MODIFICATION RECOMMENDED

6673A-10

S E R V I C E N O T E

**6673A DC POWER SUPPLY, 0-35 V, 0-60 A, 2100 W.
GPIB CONTROLLED.**

Figure 3 Regal Non locking Nut

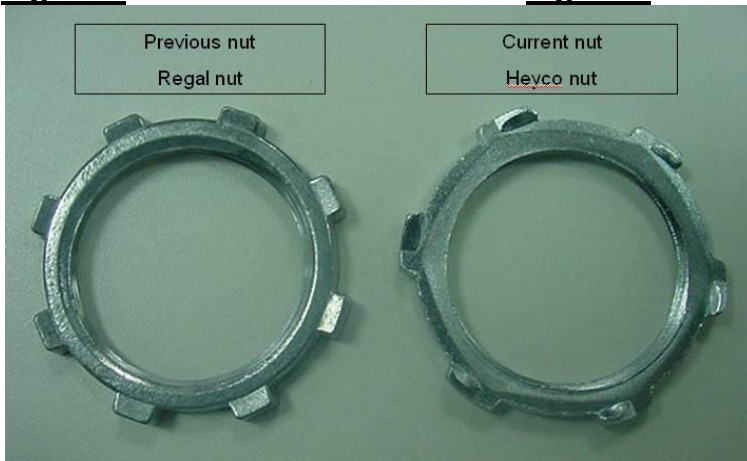
Figures 3 & 5 is representative of a not without locking ribs.

Figures 4 & 6 is representative of a nut with locking ribs.

The entire AC INPUT SAFETY COVER P/N 5040-1676 should be replaced.
